# Public Comments Received by NIST on DRAFT Reports:

NIST NCSTAR 1A Report on the Collapse of World Trade Center Building 7 - DRAFT for Public Comment

NIST NCSTAR 1-9 Structural Fire Response and Probable Collapse Sequence of World Trade Center Building 7, Volume 1 - DRAFT for Public Comment

**The Council on Tall Buildings and Urban Habitat**

FIGURE A1 : EXTRACT FROM HANDBOOK OF FIRE PROTECTION MATERIALS

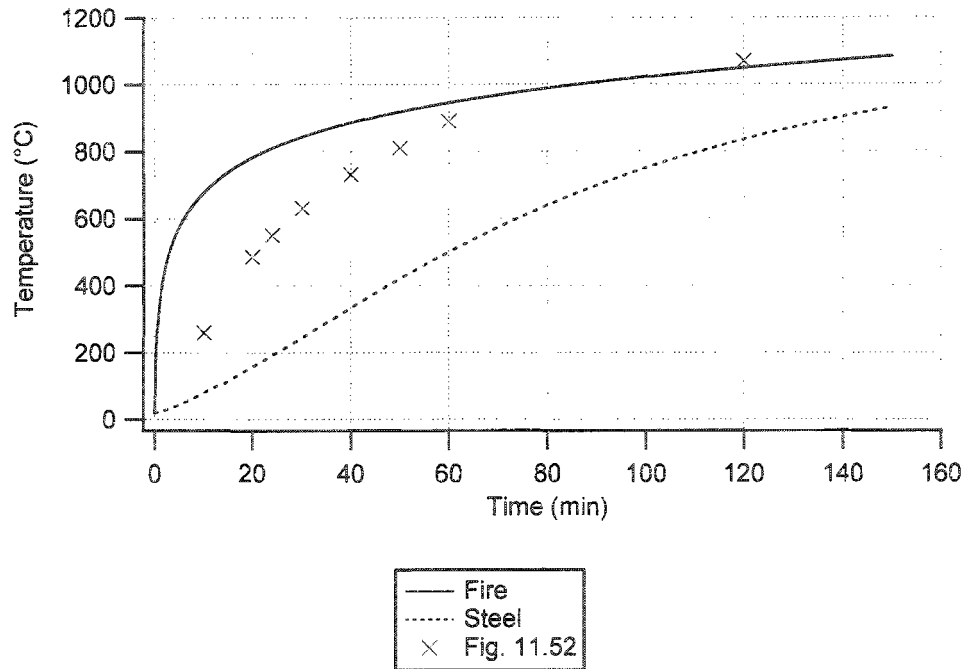
12. The thermal response calculations appear strange. We have used thermal properties derived from our local 3-sided Monokote tests to calculate steel temperatures [7]. We have obtained results similar to those shown in Fig 4.7 (p. 84), indicating that our material may be similar to that used in WTC7. We calculate a fire-resistance period of 67 mins for 0.5 inches and  $550^\circ\text{C}$ , not 120 minutes. We assume the difference may be due to the restrained fire testing used in USA, permitting higher steel temperatures. However, the results shown Fig 11.51 (p. 531) apply to the same beam and the same  $1100^\circ\text{C}$  fire temperature but produce much lower temperatures. They do not mention temperature gradient in the beam, so we are not sure whether they have considered the 3-sided exposure. At 60 mins, the 4-thermocouple average temperature from Fig. 4.7 would be about  $800^\circ\text{C}$ , while Fig 11.51 shows about  $630^\circ\text{C}$ . On the other hand, Fig 11.52 shows exposure to standard fire conditions, indicating that 0.5 inch produces  $550^\circ\text{C}$  after only 23 minutes. Surely this cannot give 120 mins even when tested restrained.

- Using a fire which was constant at  $1100^\circ\text{C}$ , the thermal response was calculated. See Fig. A3.
- The response to the  $1100^\circ\text{C}$  fire was compared with that shown in Fig. 4.7. Reasonable agreement was obtained, indicating that the Monokote materials used in Australia and USA may be similar. The thermal response from Fig. 11.51 was added. This showed poor agreement with that from Fig. 4.7, despite being for the same beam size and fire exposure case.

FIGURE A2 : STANDARD FIRE EXPOSURE

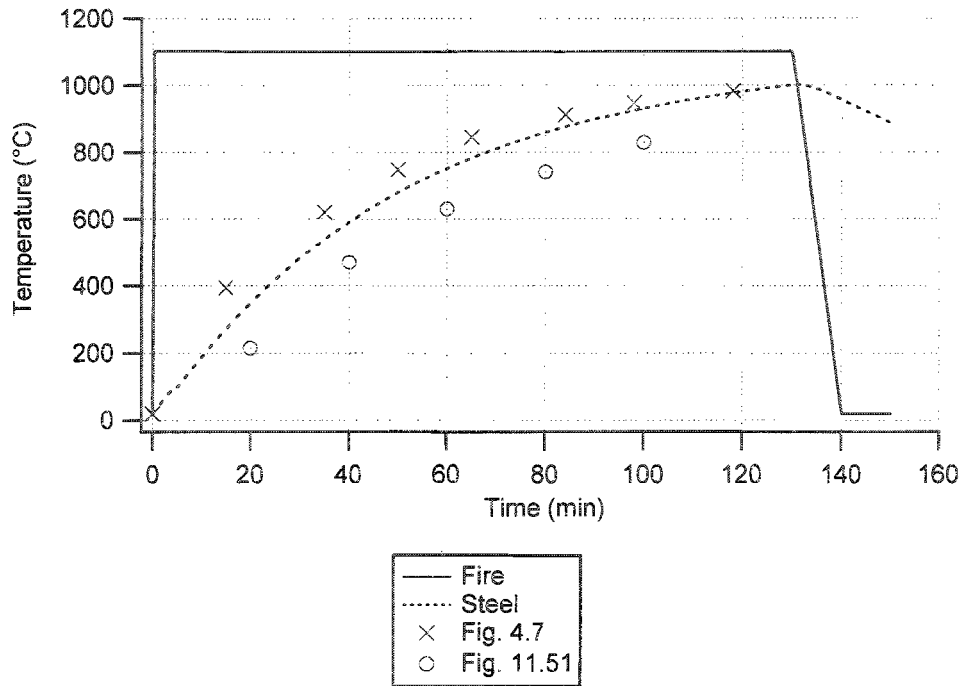
- The response for standard fire exposure was taken from Fig. 11.52 and added to Fig. A2. Again, this showed poor agreement.

Figure B-9. Events identified on PAL seismogram.  
Refer to Table B-4 for location, strength and description of event type.

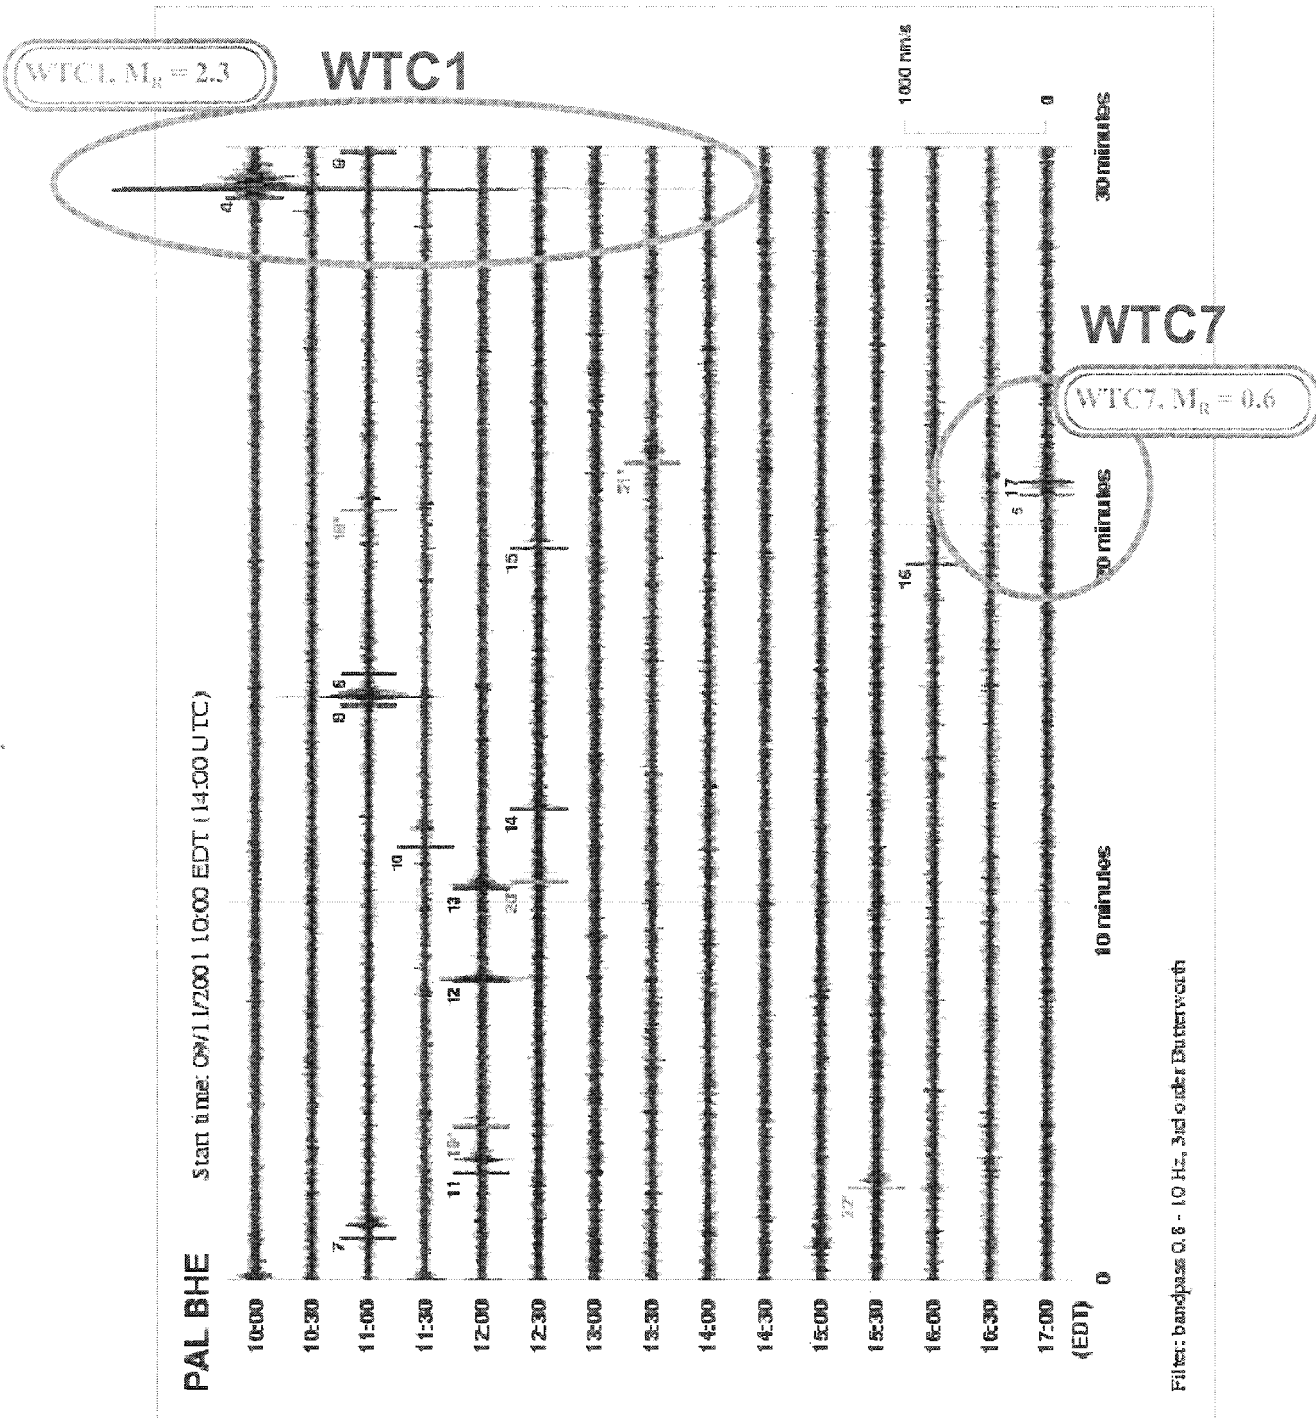
The collapse time for the building is not addressed. Analysis is incomplete and inconsistent with time the ground shook. Add: the sound heard should have been comparable with a fleet of dump trucks crashing to the ground (one only has to consider the noise and vibration of one that is loaded when it passes by a pedestrian on the sidewalk). In complete and should be addressed.

Figure 12–69 Exterior buckling after global collapse initiation.

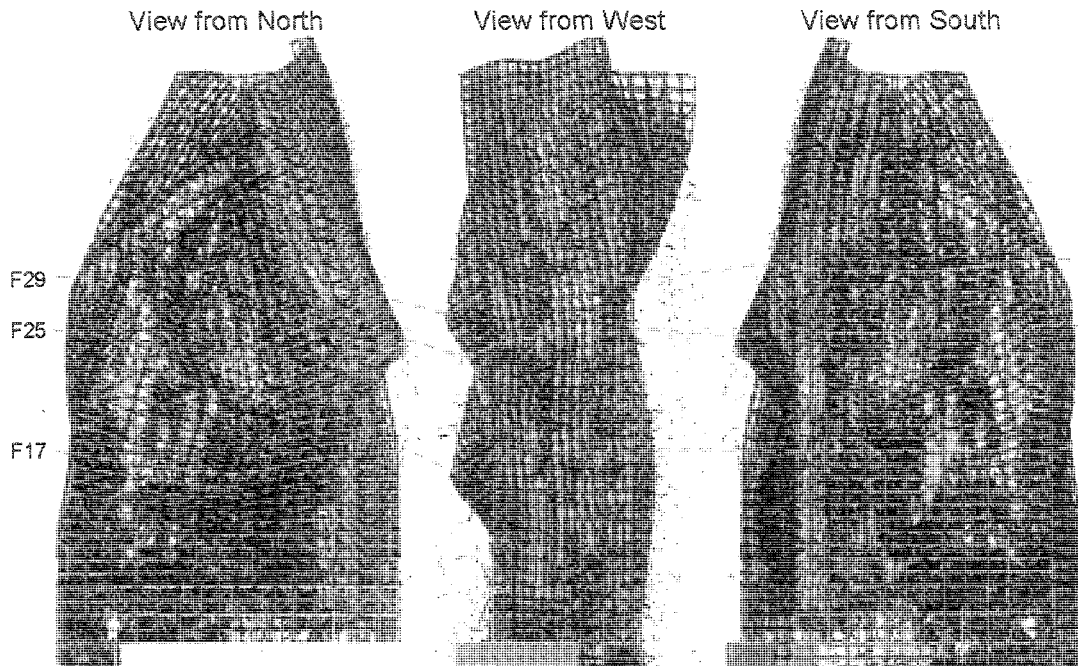
Now consider NIST’s version of the final moments of WTC 7 as exemplified by the computer-generated simulacra of Figure 12-69 of NCSTAR 1-9. These images of the final collapse of WTC 7 from the north, west and south show very extensive buckling of the exterior columns especially near the mid-height of the building. It is simply astounding that, even though these computer generated images of a crumpled and severely distorted Building 7 look nothing like the video images of the real thing, NIST nevertheless concludes: “*the global collapse analyses matched the observed behavior reasonably well.*”
